## CONSTRUCTION AND RIGHT-OF-WAY PLANS FOR: BR 1-084 ON N234 TWADDELL MILL ROAD OVER TRIBUTARY TO BRANDYWINE CREEK

CONTRACT NUMBER: T201907103  
FEDERAL AID PROJECT NUMBER: N/A

<b>ADDENDUM PREPARED BY</b> DELDOT - TRANSPORTATION SOLUTIONS BRIDGE DESIGN		
	6/15/26 DATE	
THIS SEAL APPLIES TO THE FOLLOWING SHEETS CHANGED UNDER ADDENDUM #1: 2, 4, 10, 10A		SEAL

APPENDUM 1  
June 22, 2026

**BRIDGE SECTION A-A**  
3/8" = 1' - 0"

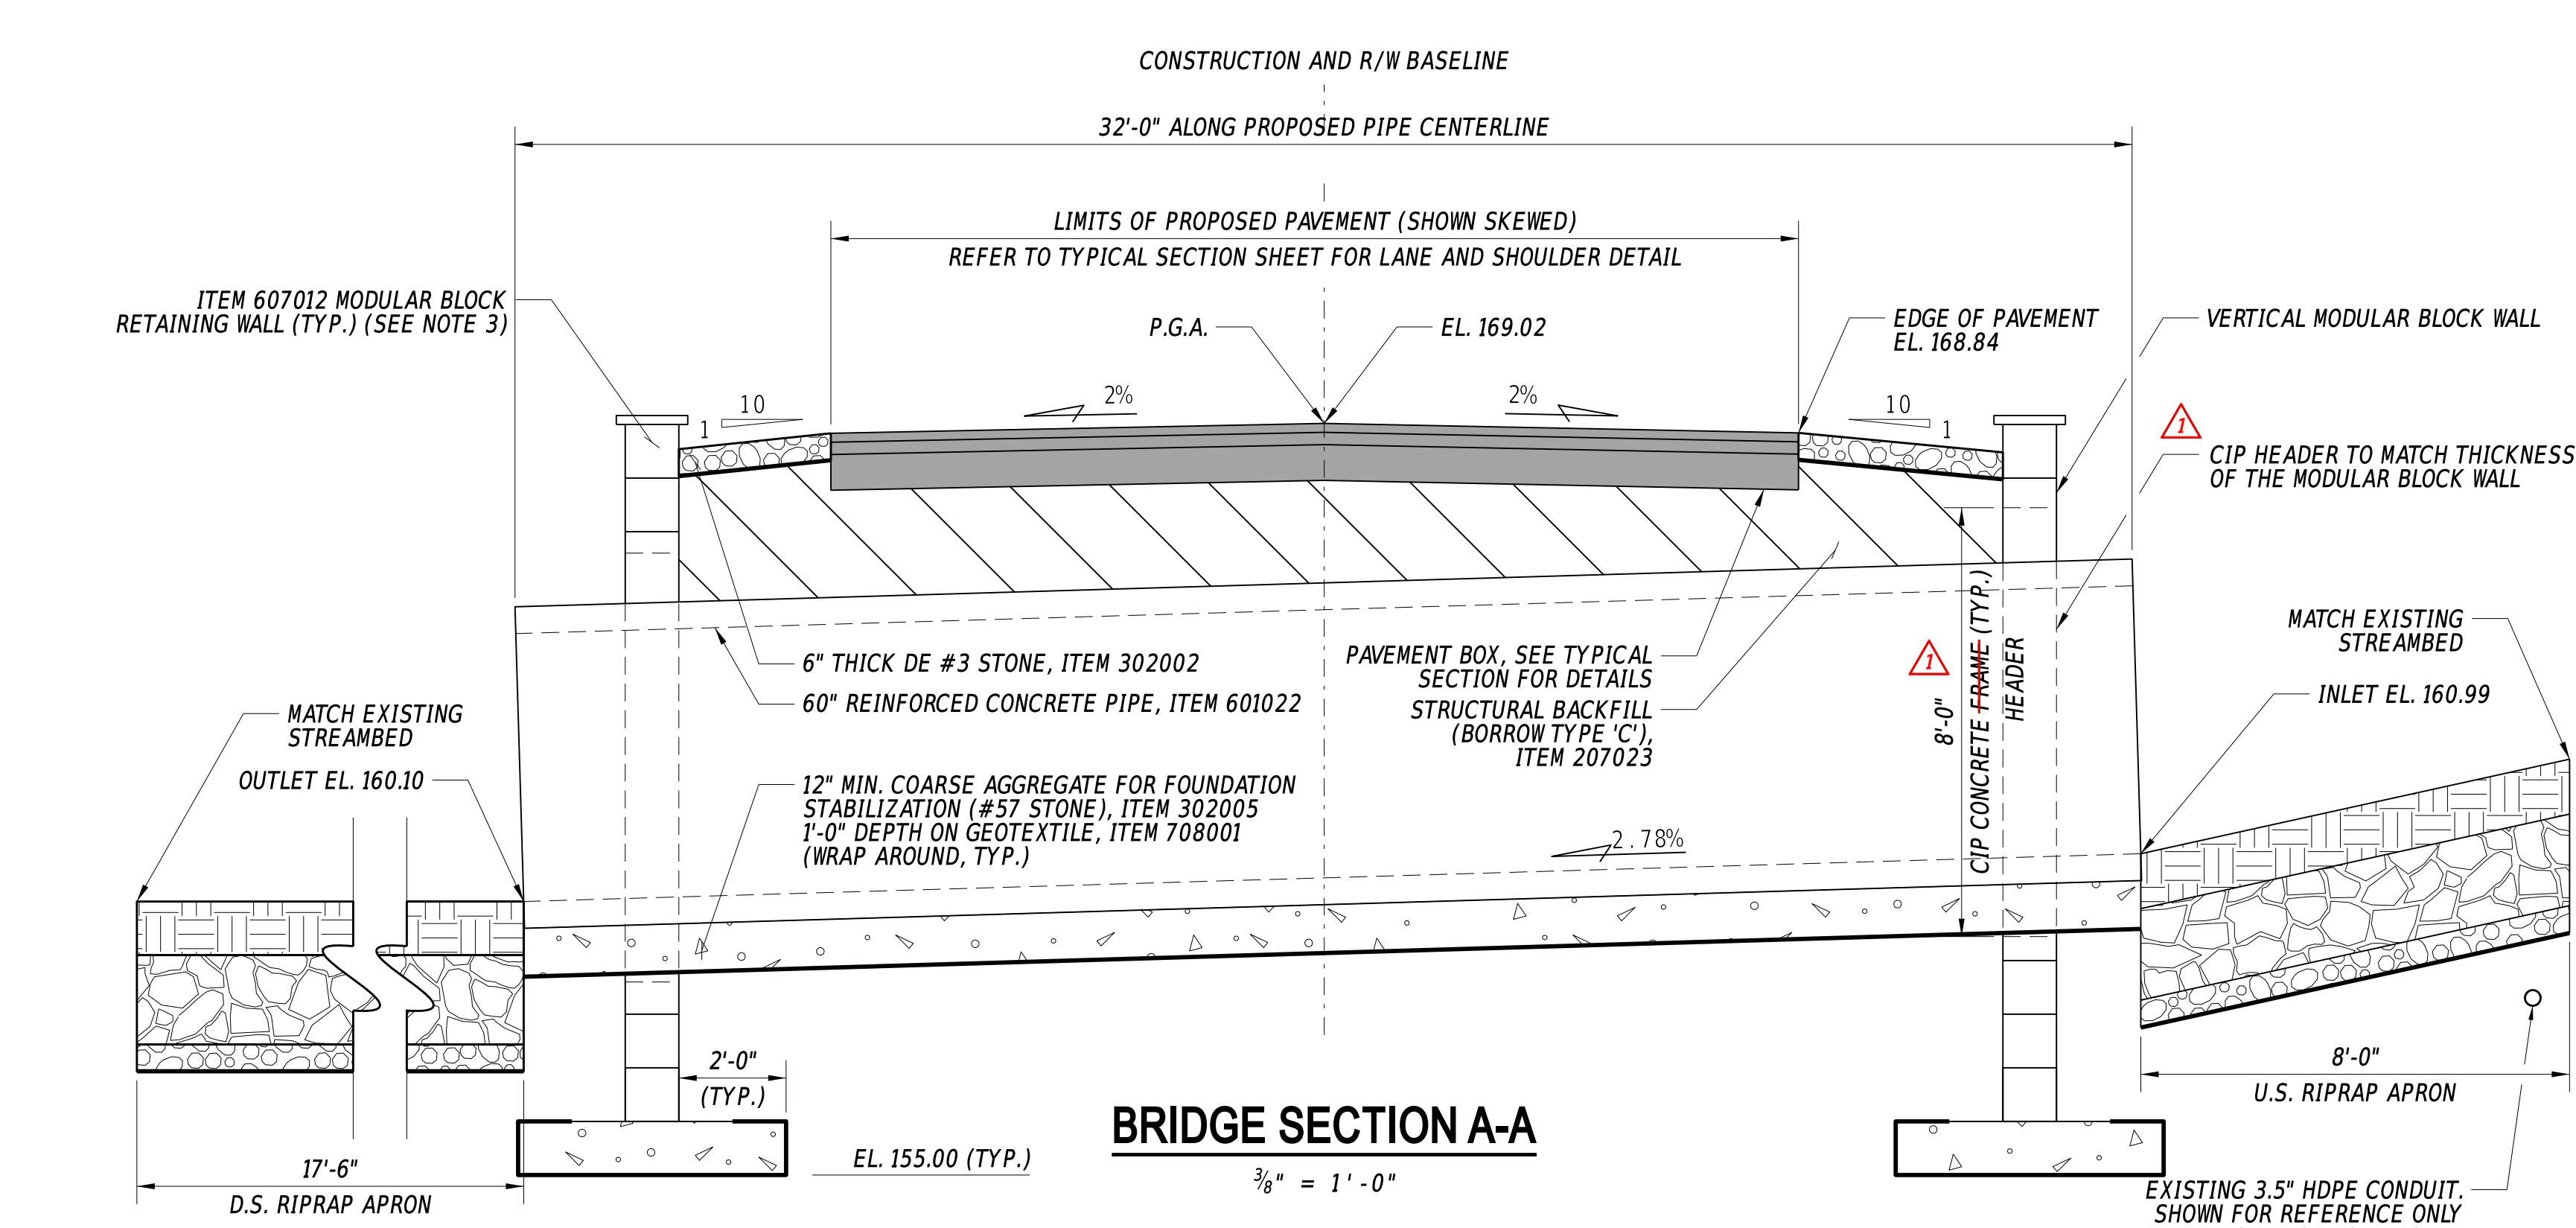
ADDENDA / REVISIONS
REVISOR: REVISED THE NOTES CONCERNING THE CONCRETE HEADER - PCH 6/15/2026

- NOTES:
- IN THE SUBMITTAL (STANDARD SPEC 607.3.1), INCLUDE SHAPE AND SETBACK OF BRICKS WHICH SHALL BE FLAT FACED, AND NEAR VERTICAL. THE COLOR OF THE BRICKS SHALL BE DELAWARE BLUE GRANITE OR SIMILAR, TO BE APPROVED BY ENGINEER.
  - DUE TO MODULAR BLOCK RETAINING WALL BEING DESIGNED BY MANUFACTURER AND VARIATION IN EXISTING CONDITIONS, CONTRACTOR AND ENGINEER WILL DETERMINE WHETHER OR NOT STEPPING OF MODULAR WALL IS NECESSARY. FOR QUANTITY ESTIMATION PURPOSES, IT WAS ASSUMED STEPS OF 2'-0" WERE USED.
  - FOR QUANTITY ESTIMATION OF ITEM 607012, THE DEPTH AND REQUIRED AMOUNT OF MODULAR BLOCK RETAINING WALLS WERE ESTIMATED BASED ON BORING LOGS AND STEPS MENTIONED IN NOTE 2. THE SIZE OF POSSIBLE LEVELING PAD/FOUNDATION FOR MODULAR BLOCK RETAINING WALLS WERE ESTIMATED TO BE 1'-0" DEEP AND 5'-0" WIDE FOR ITEM 708001 - DE #57 STONE.

<b>CULVERT DETAILS</b>	SECTION	BR
	SHEET NO.	10A

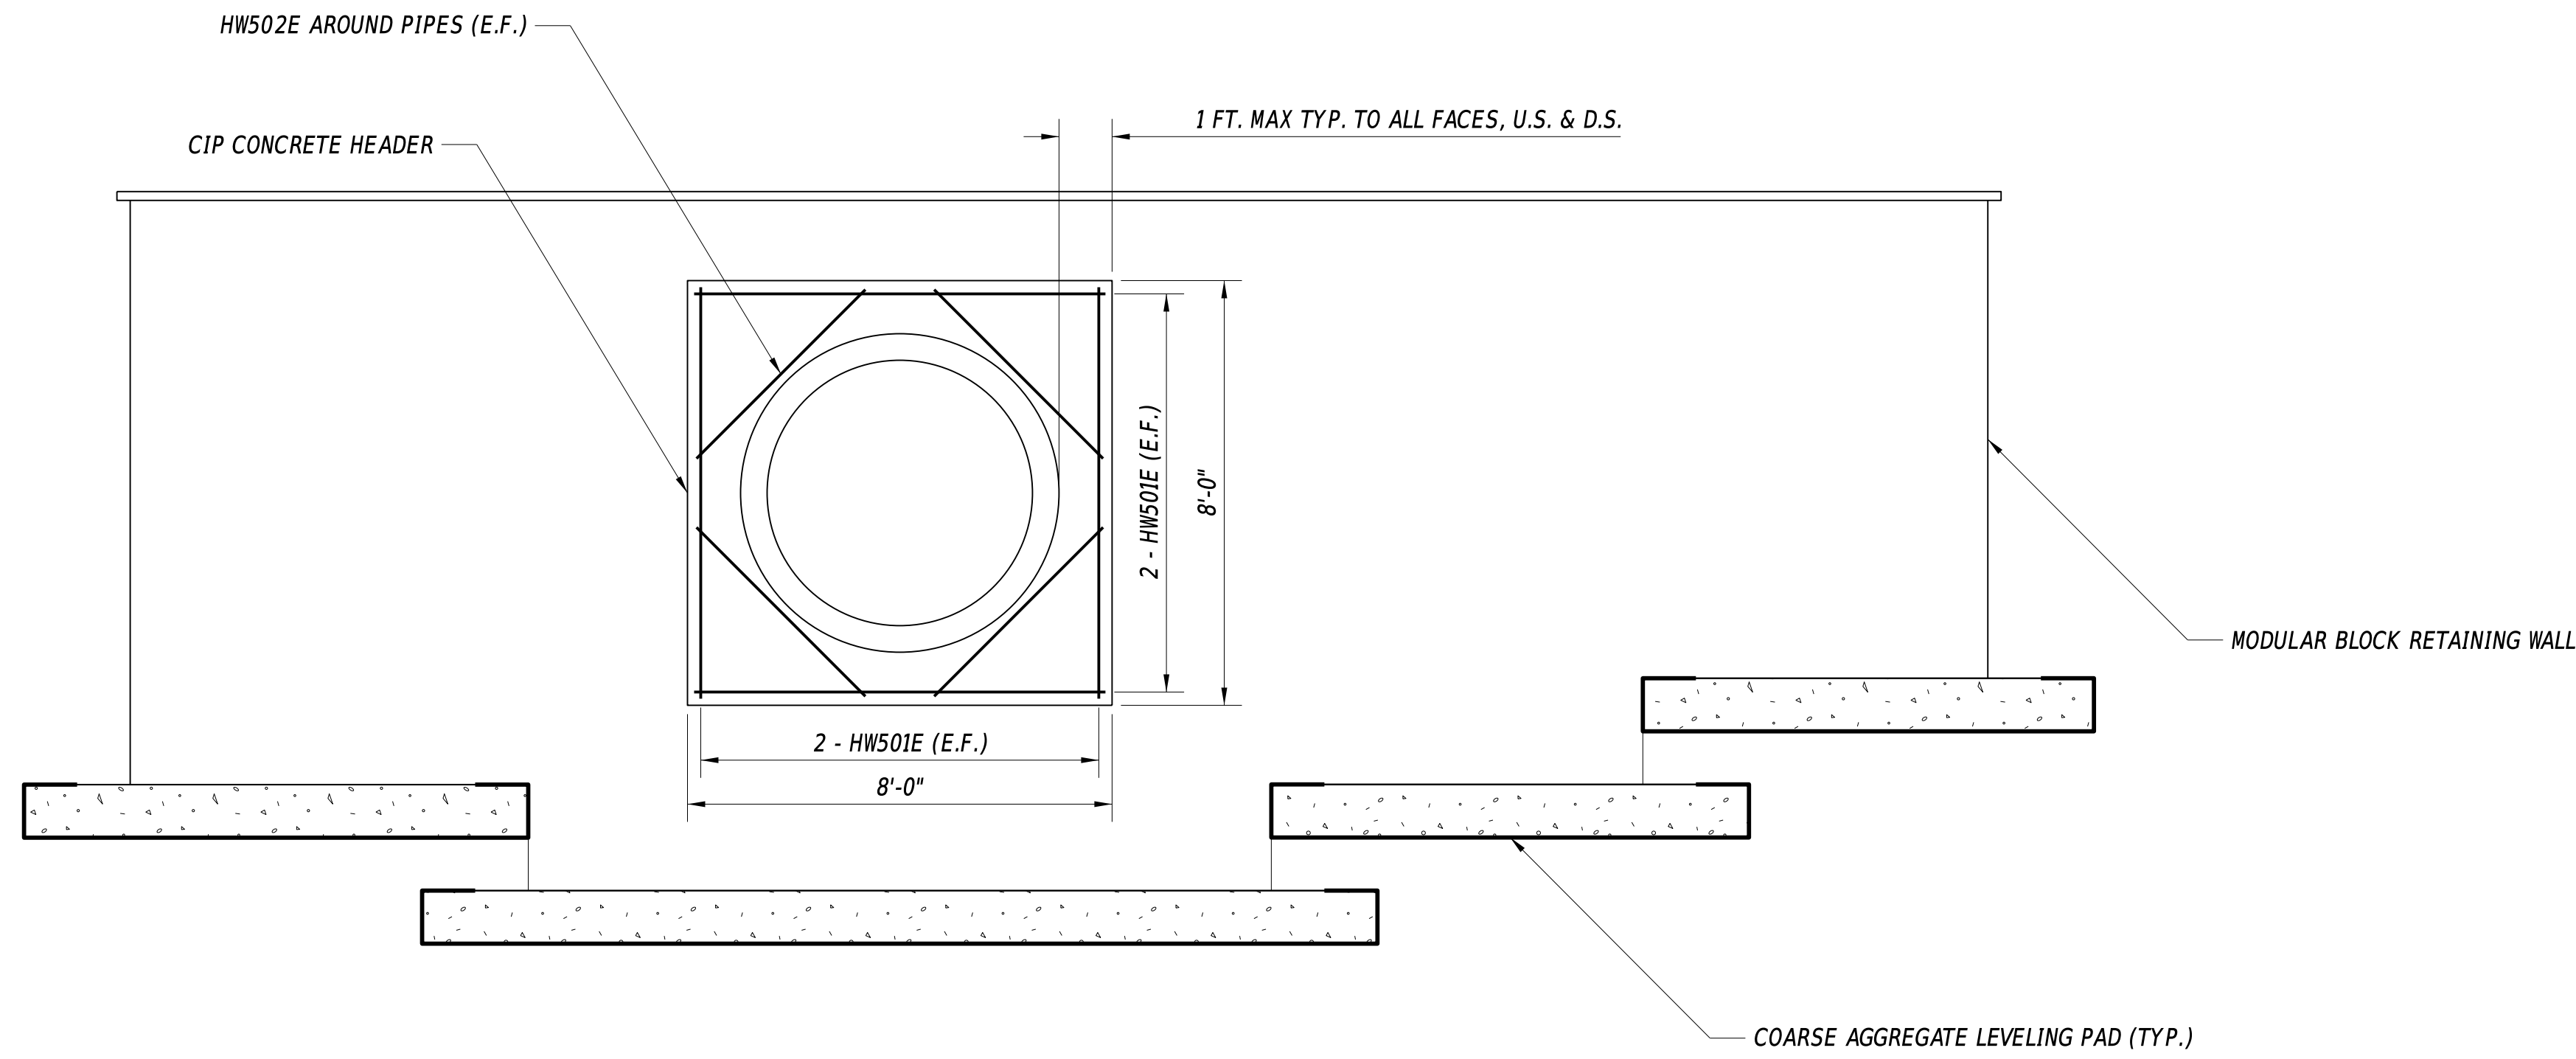
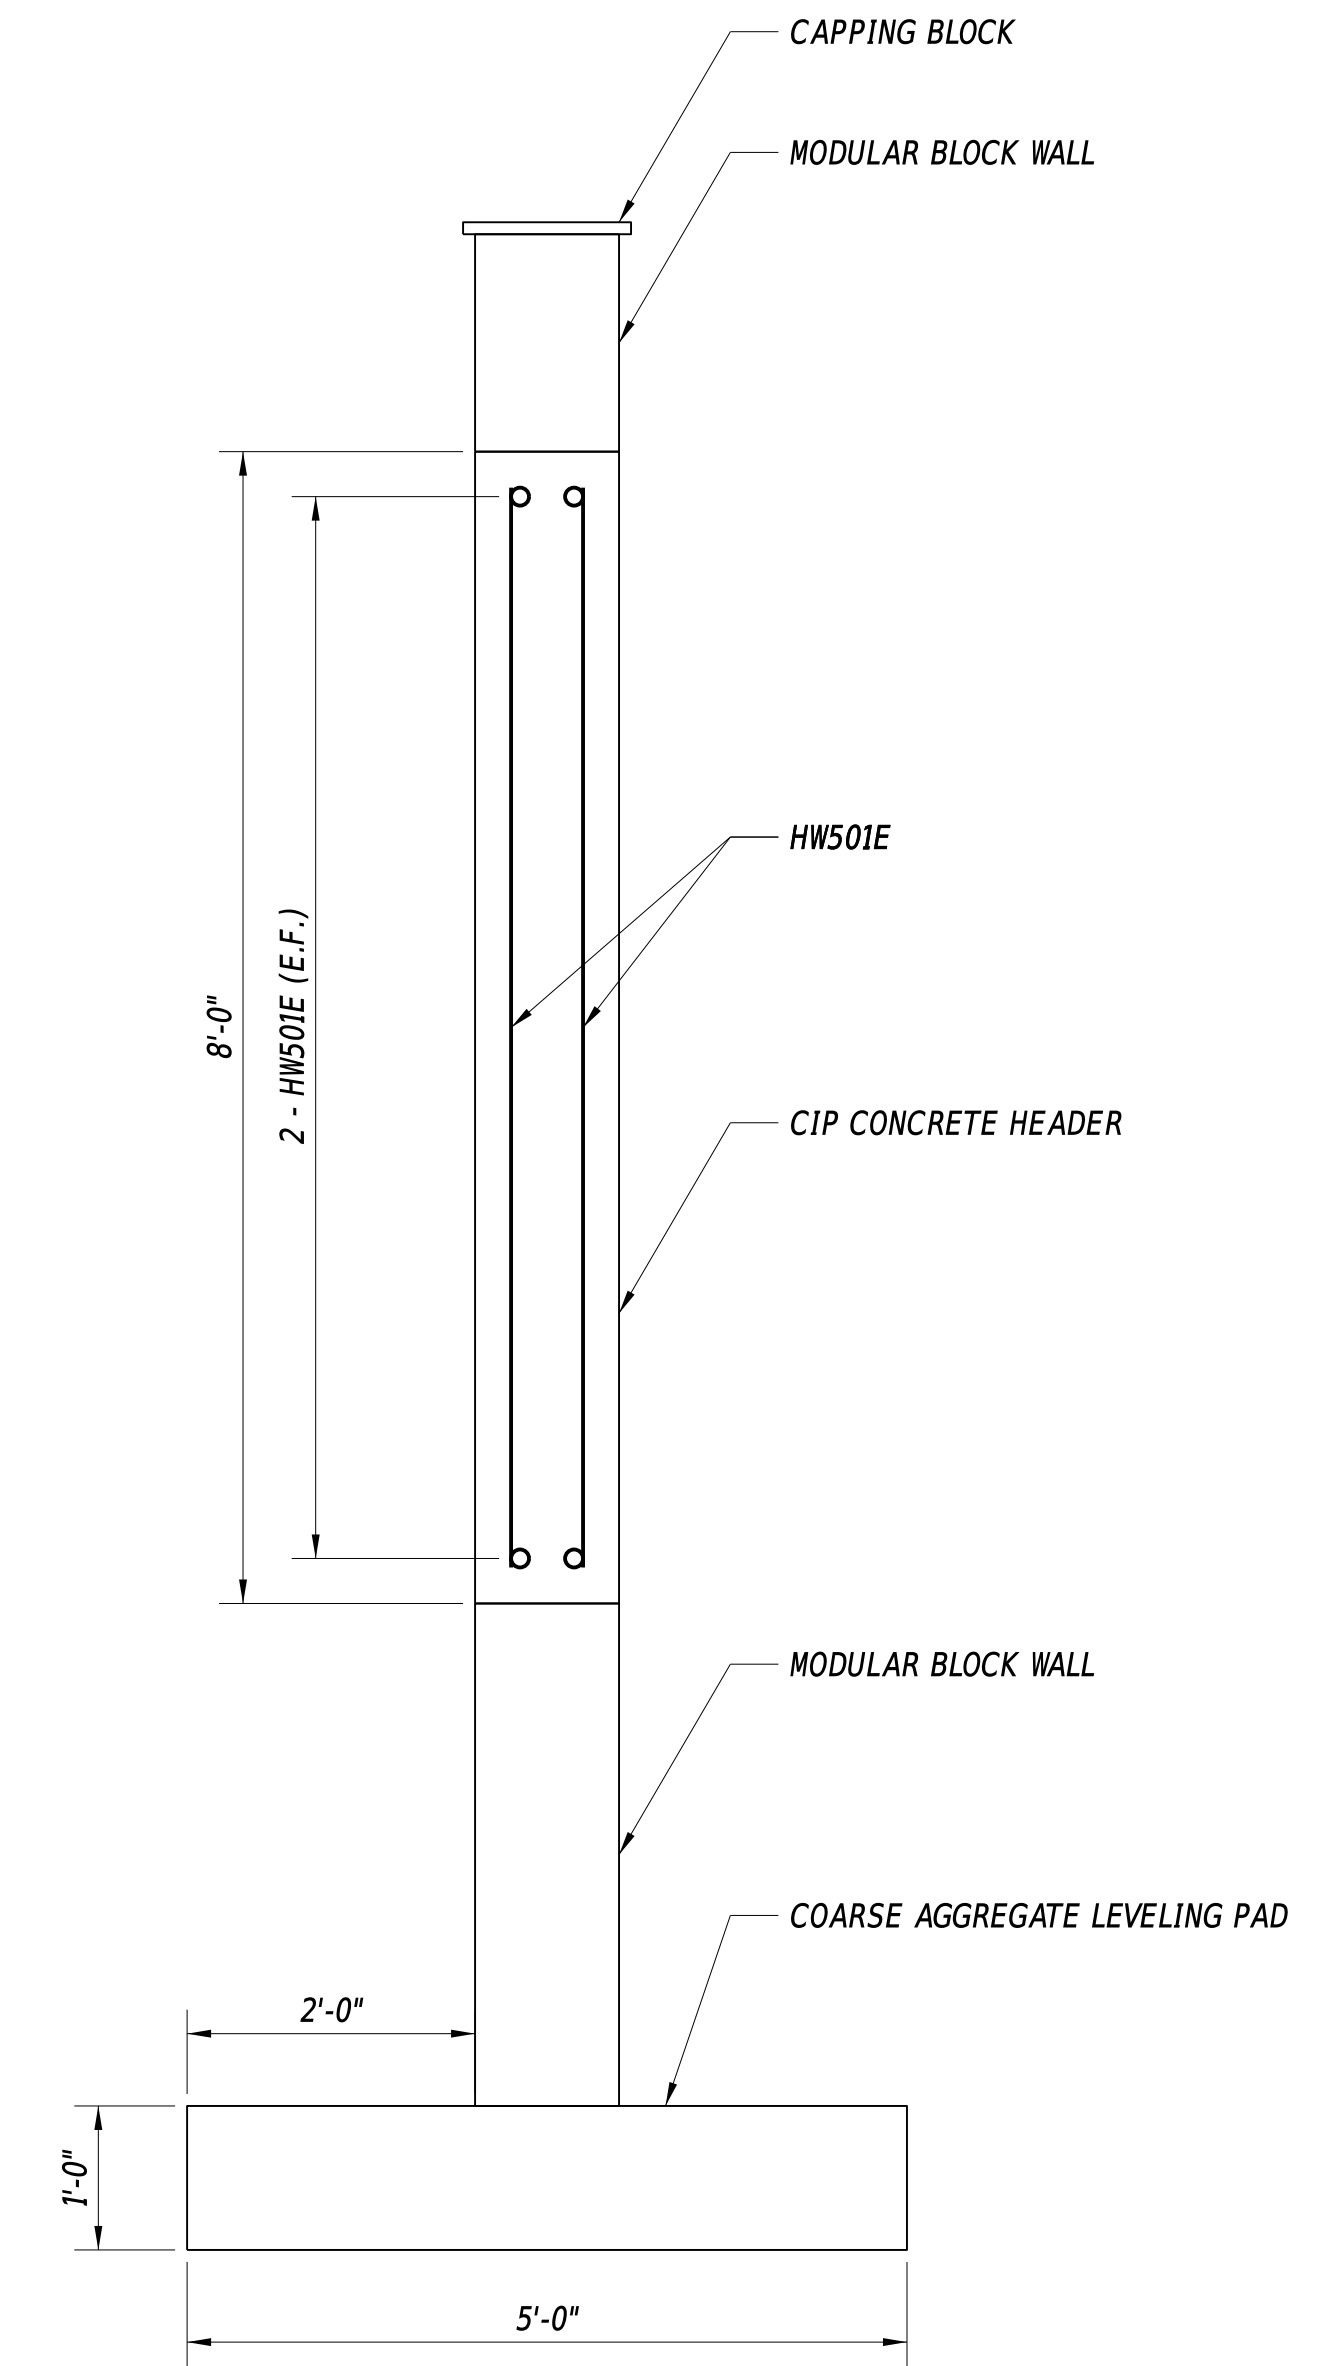
ADDENDA / REVISIONS	
NEW SHEET ADDED - PCH 6/15/2026

\*FIELD CUT HW502E TO LENGTH REQUIRED AND RECOAT FIELD CUTS IN ACCORDANCE WITH SECTION 611.3.D OF THE STANDARD SPECIFICATIONS.
